## **DART SERVICE INSTRUCTION**

TO AMEND INSTALLATION INSTRUCTIONS IIN-D119-675 REV. A
REF. FAA STC: SR00948SE

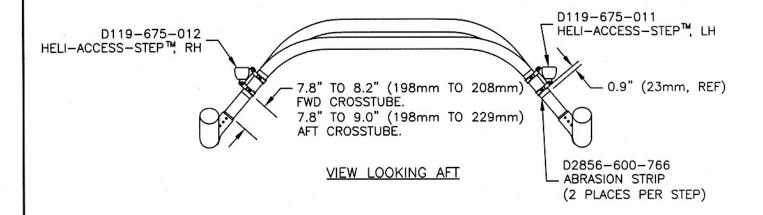
- 1) FIND THE APPROPRIATE STEP HEIGHT BY LOCATING THE STEP/ CLAMP AS SHOWN BELOW. LOCATE THE FORWARD D3041-3 CLAMP 7.8"-8.2" ABOVE THE CROSSTUBE CUFF. LOCATE THE AFT D3041-1 CLAMP 7.8"-9.0" ABOVE THE CROSSTUBE CUFF. THE DISTANCES GIVEN ARE FROM THE CROSSTUBE CUFF TO THE BOTTOM-MOST CLAMP. CENTER THE ABRASION STRIP UNDER THE CLAMPS, AS SHOWN BELOW.
- 2) WHEN REMOVING THE EXISTING SHORT STEPS, FILL HOLES IN THE CROSSTUBES WITH NAS173826-5 RIVETS (OR EQUIVALENT).
- 3) NOTE THAT IT IS ACCEPTABLE TO LEAVE THE SHORT STEPS ON THE LANDING GEAR PROVIDED THE DART STEP IS INSTALLED IN ACCORDANCE WITH THE DIMENSIONS GIVEN BELOW.
